1305 STEWART

PROJECT NUMBER
3034882-EG

PROJECT ADDRESS
1305 Stewart Street
Seattle, WA 98109

EDG 3 GUIDANCE

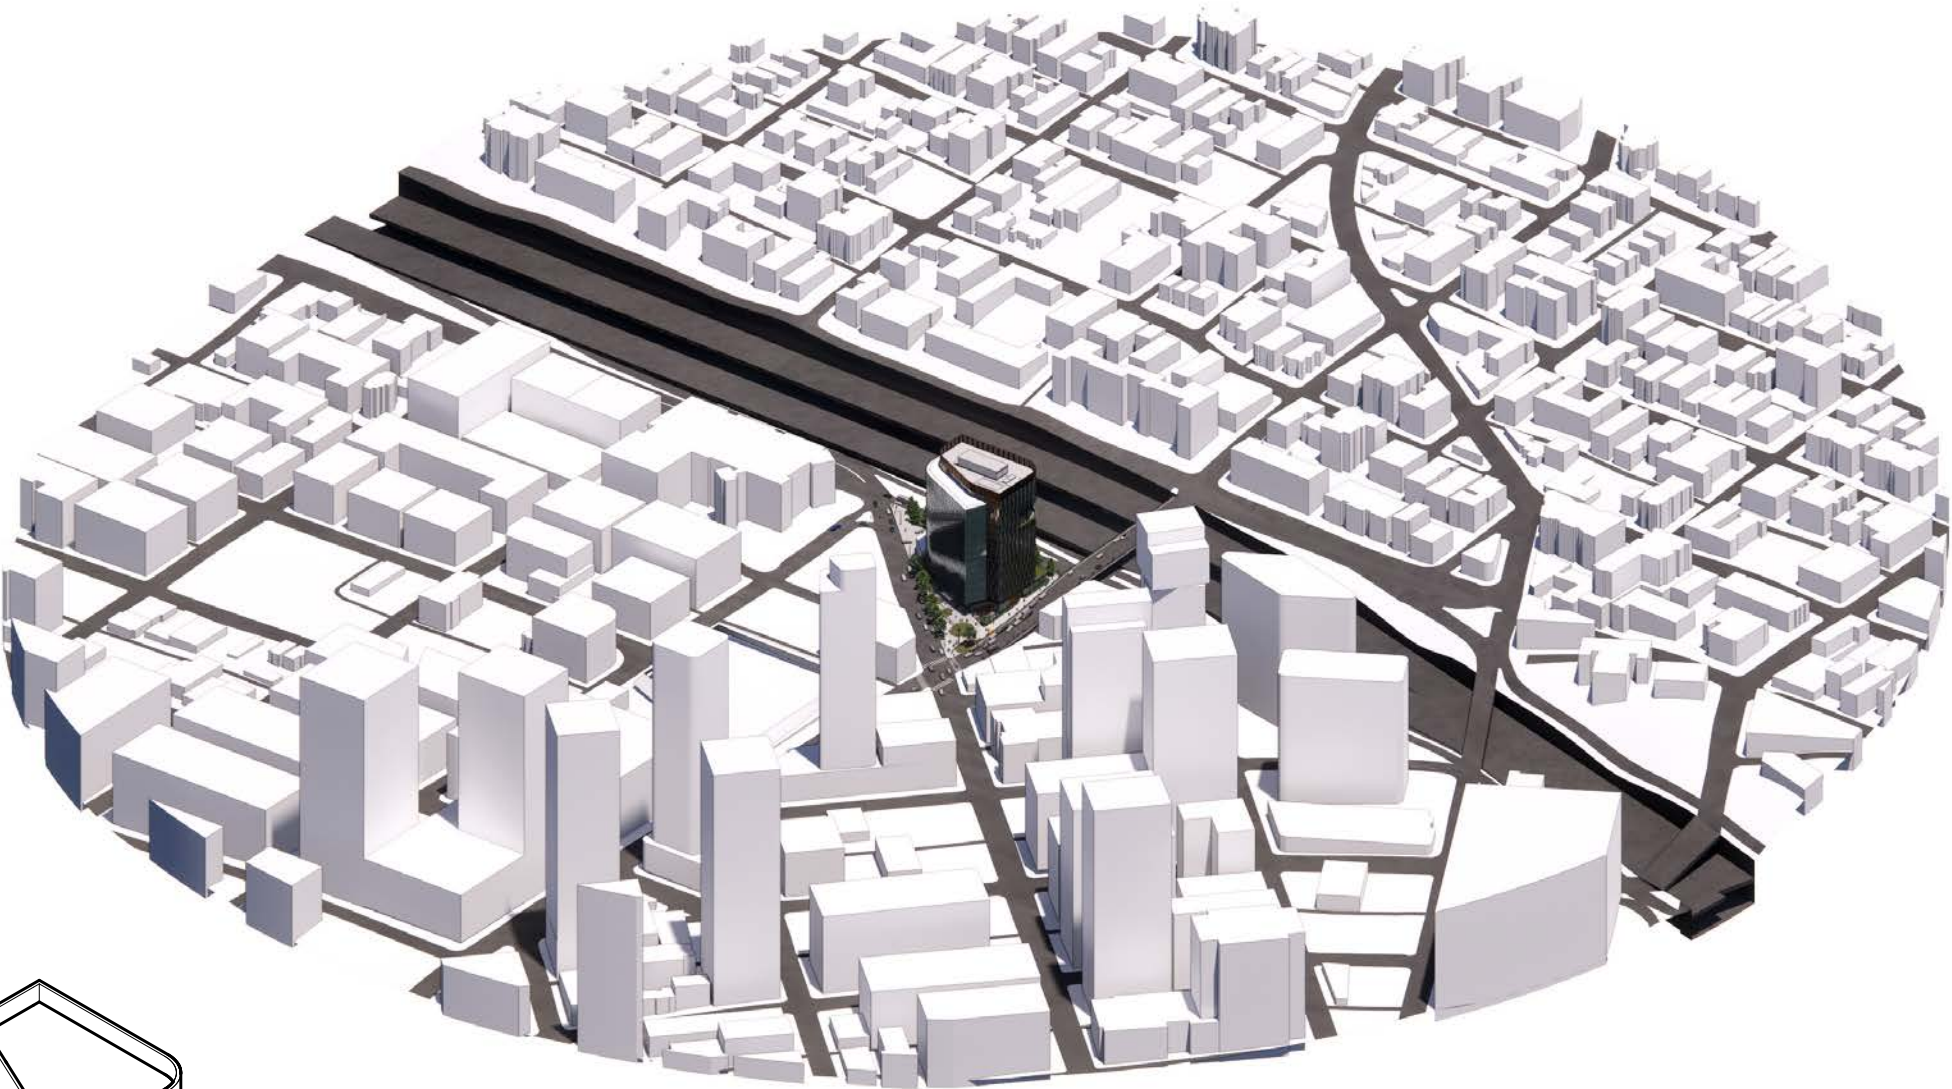
EDG3 Priorities & Board Recommendations /
3. Podium Massing and Expression

a. The Board expressed general support for the articulation of the base as a distinct compositional element, shown as inset at Stewart Street and projecting at Eastlake Avenue, as a response to context and the Design Guidelines. (CS2-4. CS3-A. DC2-3. DC2-4)

a. The base remains articulated as a distinct compositional element, shown as inset at Stewart Street and projecting at Eastlake Avenue. A high level of transparency is detailed on Stewart and Denny. Landscape is incorporated. The planning and programming of Denny have been revised since EDG3 to feature active uses by relocating the SCL vault to Eastlake.

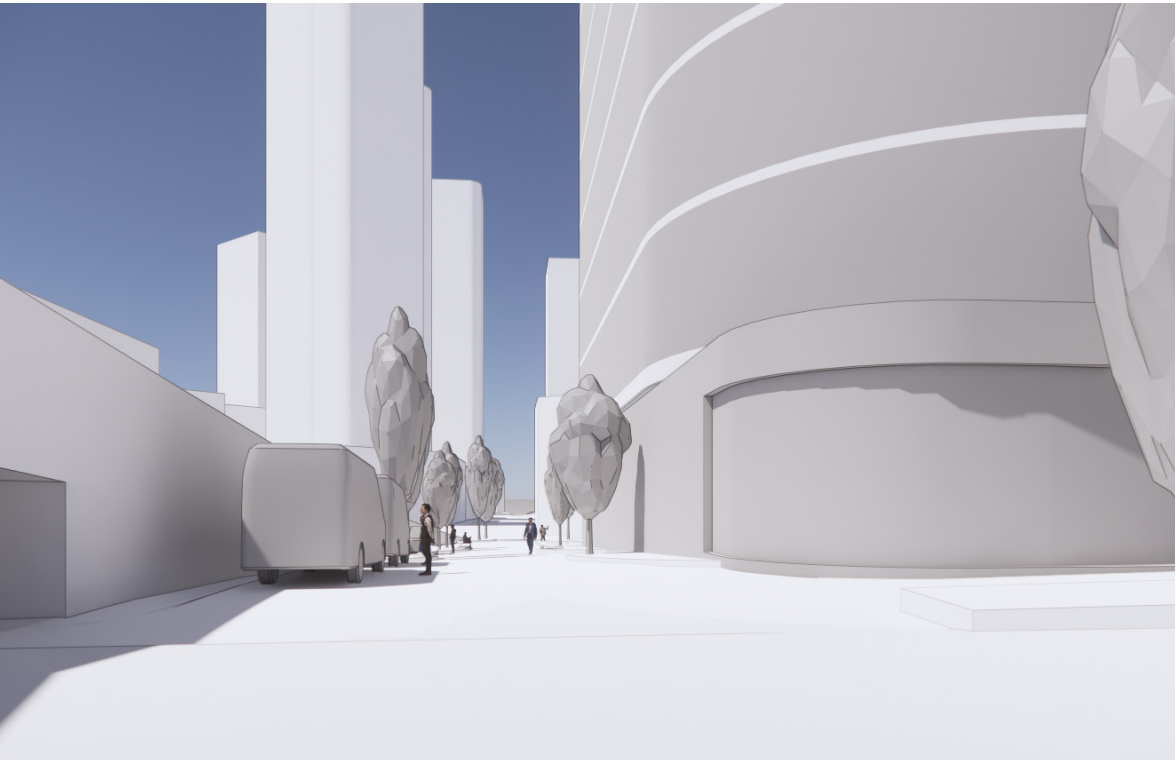
b. The Board agreed that the expression of the base at the southeast corner and at Lower Denny was unresolved, particularly where it appeared to become coplanar with the tower above. The Board agreed that the solution need not be the same strong horizontal delineation used elsewhere and that this could be resolved in a number of ways, including with materials and with areas where the tower expression could be carried down to grade. (DC2. DC2-3. DC2-4)

b. The base and tower relationship where the two are coplanar is resolved in a number of ways, including with changes in material expression, a clear horizontal element that reads as both "gasket" and "plane". The tower material also carries through in this zone, creating a "both/and" design that differentiates tower and podium within a unified overall design expression. The programming, detailing, and material treatments on each frontage create a human and civic scale appropriate to the character and improvements proposed for each street edge.

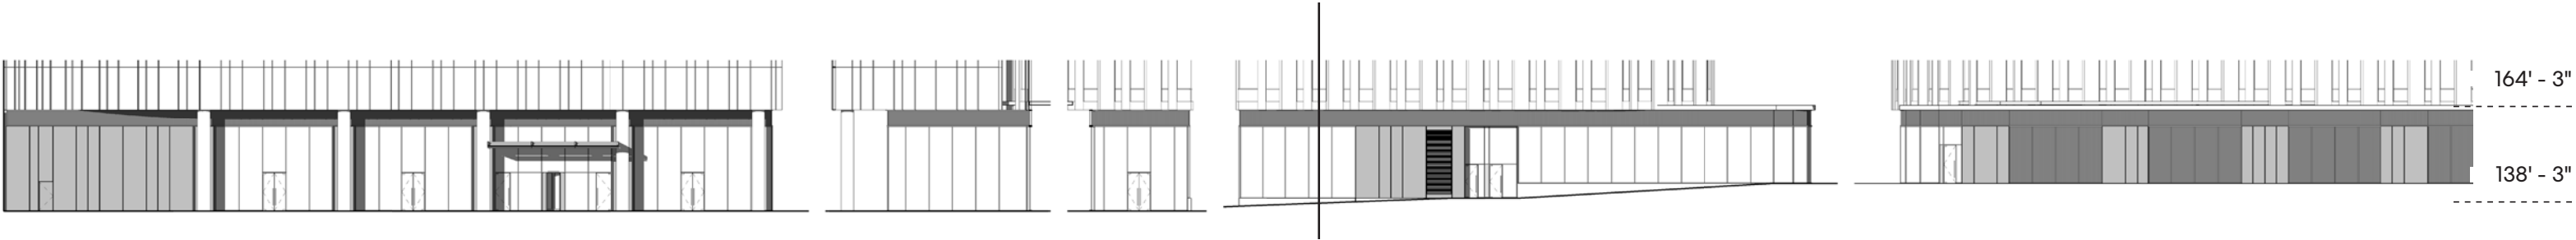
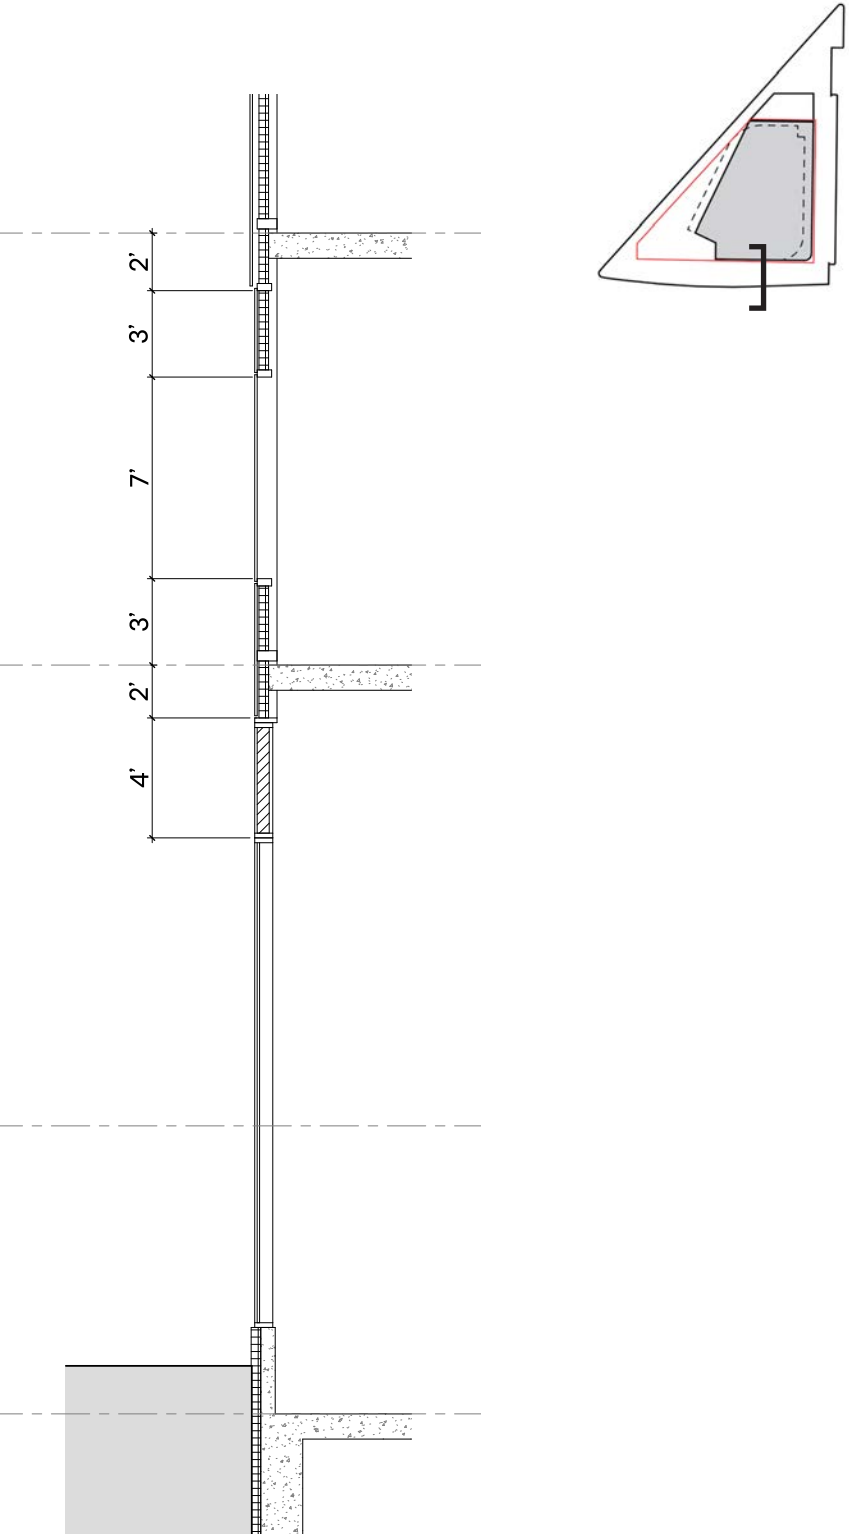
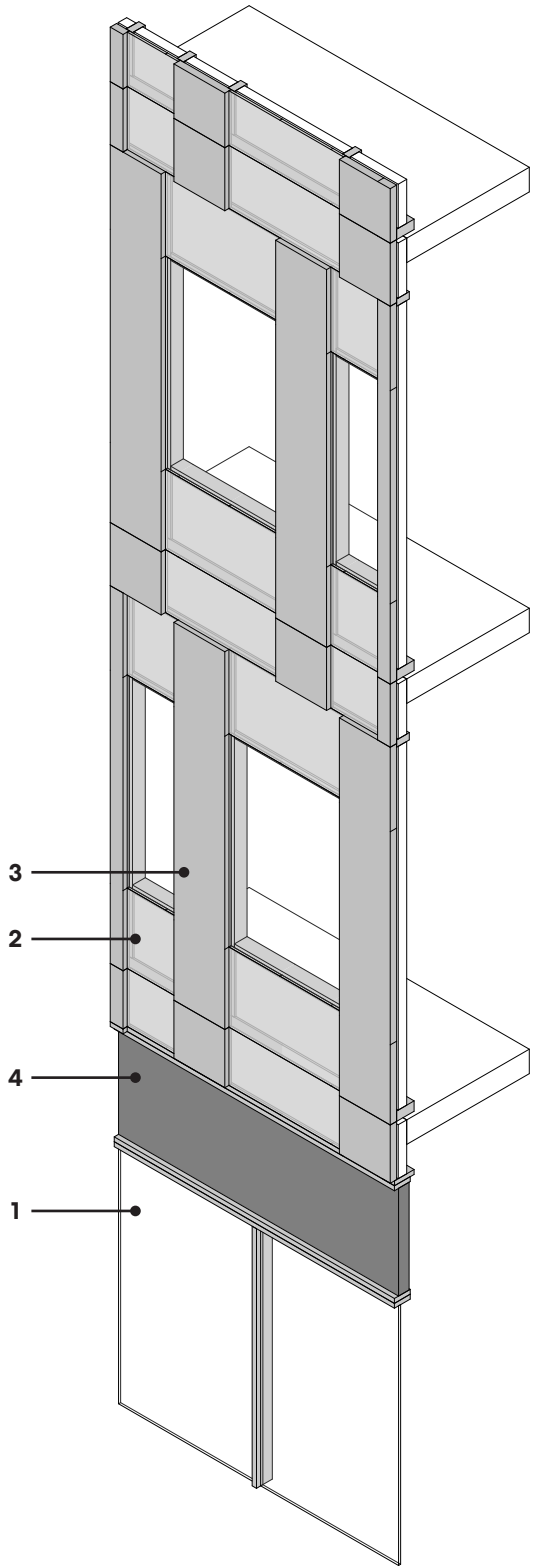
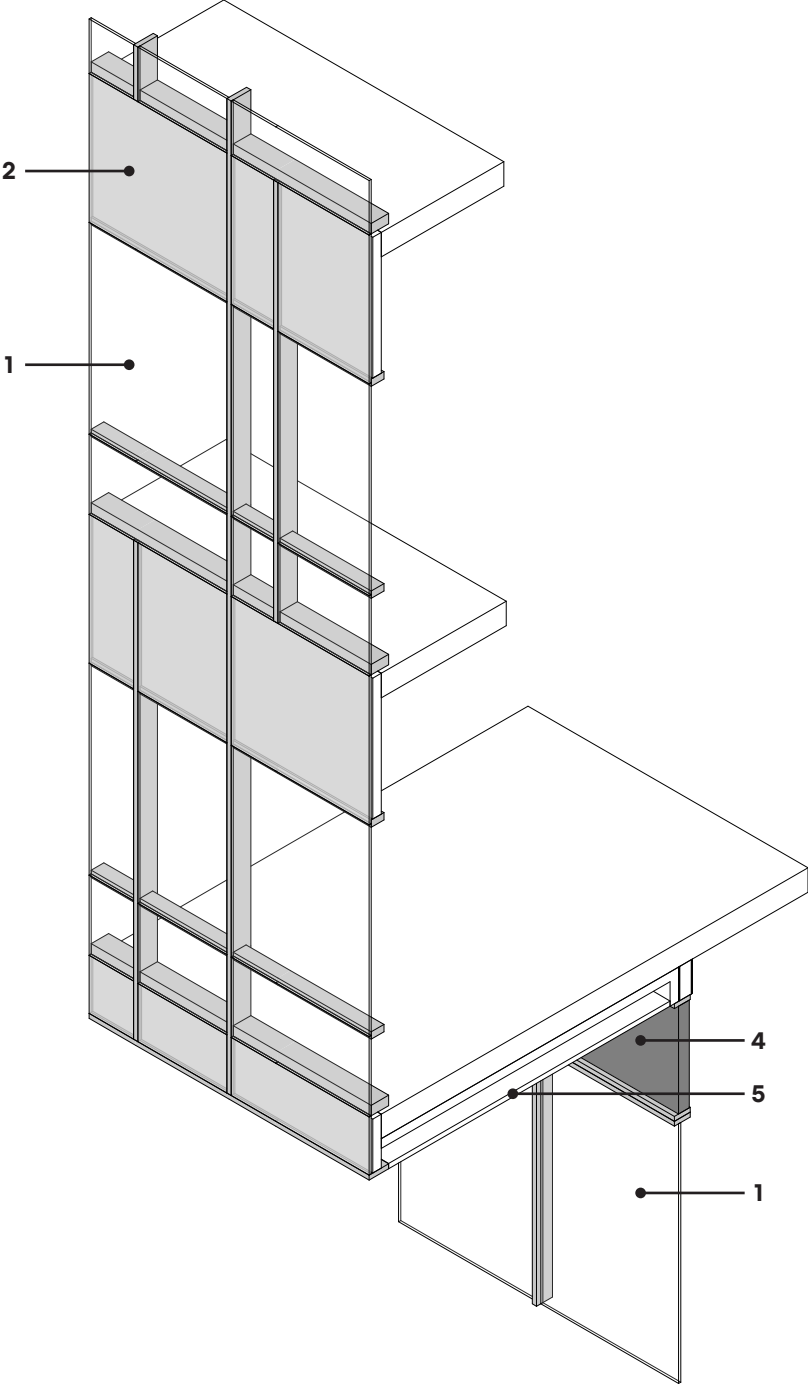
c. The Board noted what appeared to be a gasket between the base and tower on page 47 and agreed that if this were well executed it would have the potential to help resolve the transition between base and tower at that corner. (DC2, DC2-3, DC2-4)

c. The gasket between the base and tower is executed as a key concept to resolve the transition between base and tower.

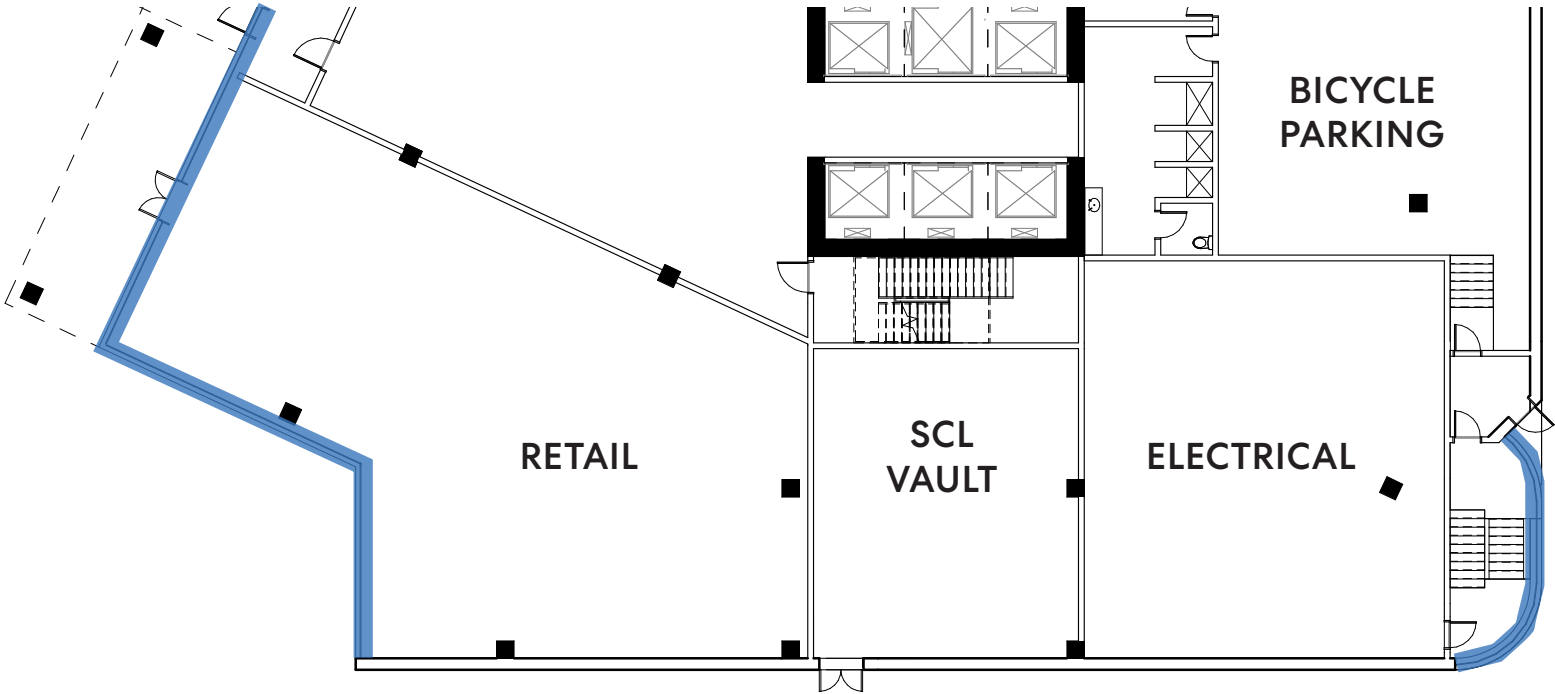
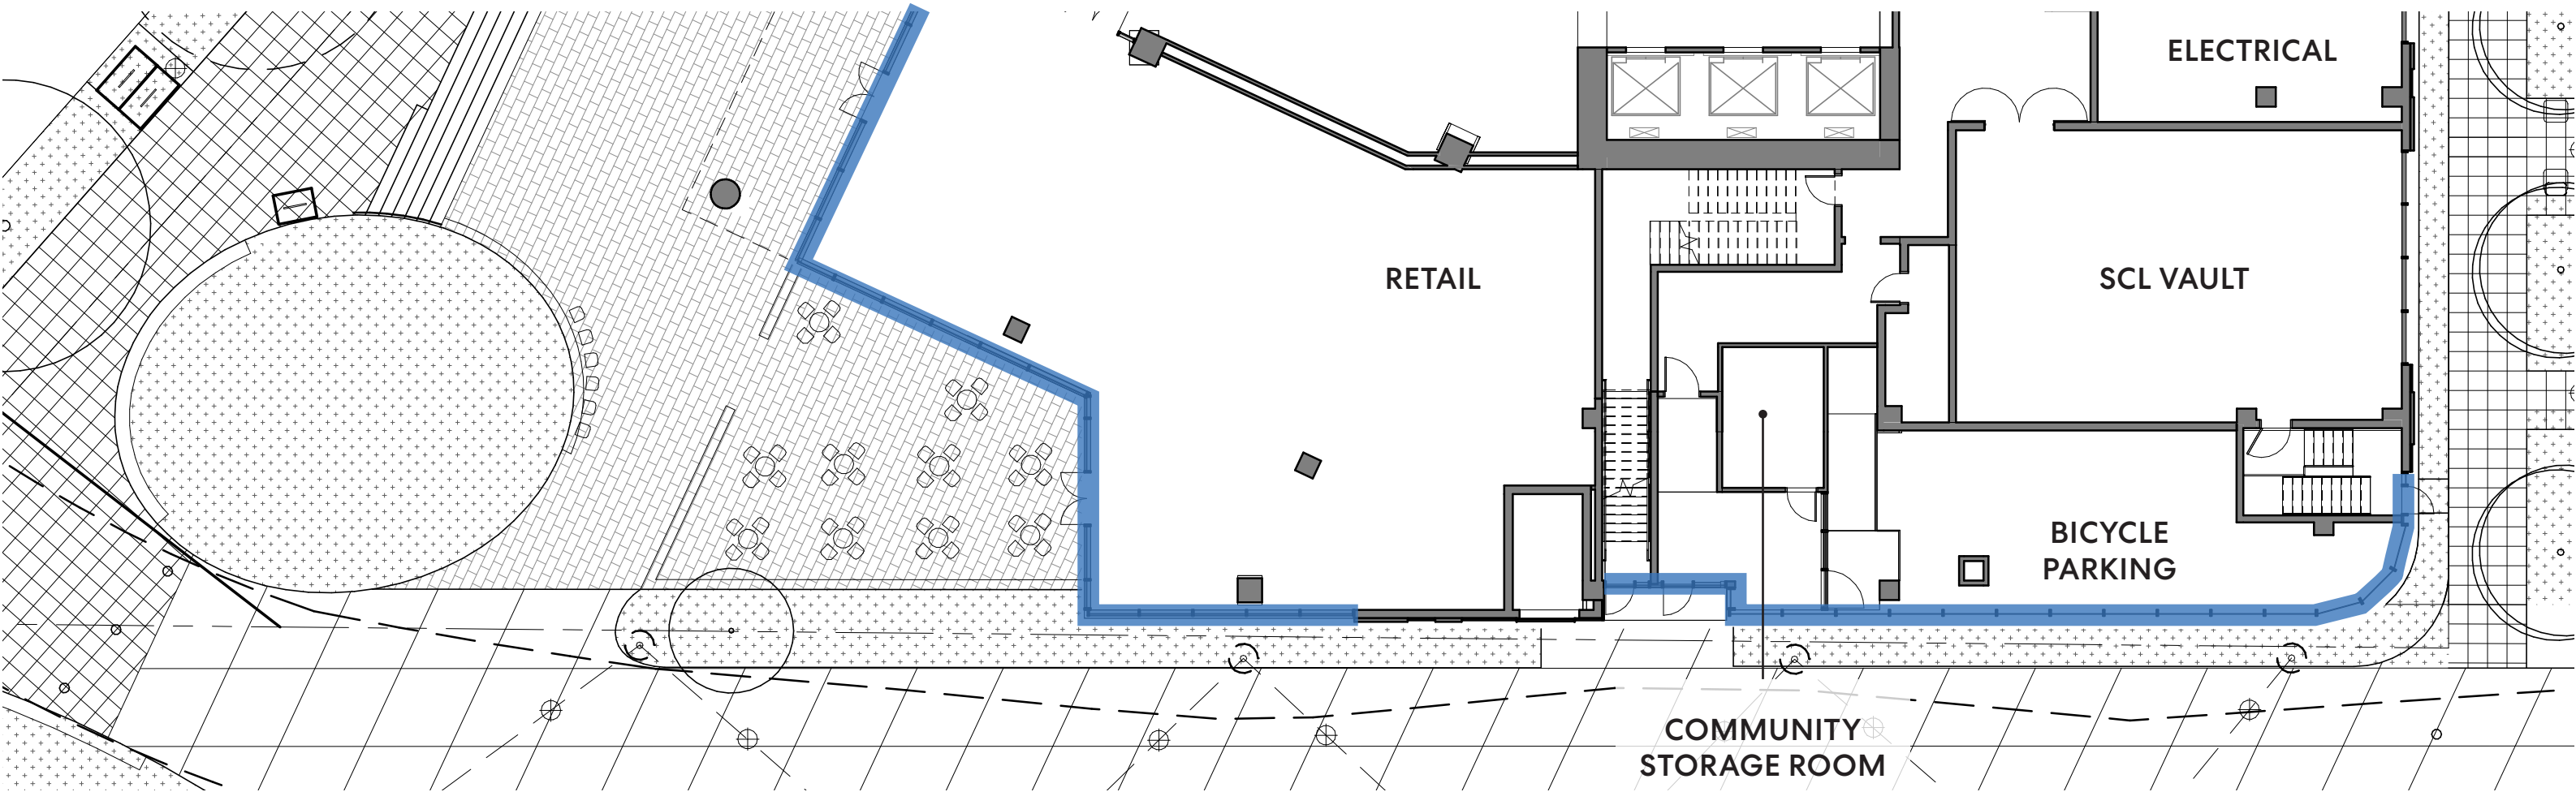
c. The Board supported the rounded corner at Lower Denny and Eastlake Avenue and encouraged the applicant to further round this corner, as it shortened the visual distance between Eastlake Avenue and Stewart Street and created clearer sightlines for pedestrian safety. (PL1-B)

c. The rounded corner at Lower Denny and Eastlake Avenue has been developed and enhanced through programming, planning, and design to create a welcoming feature at this corner.
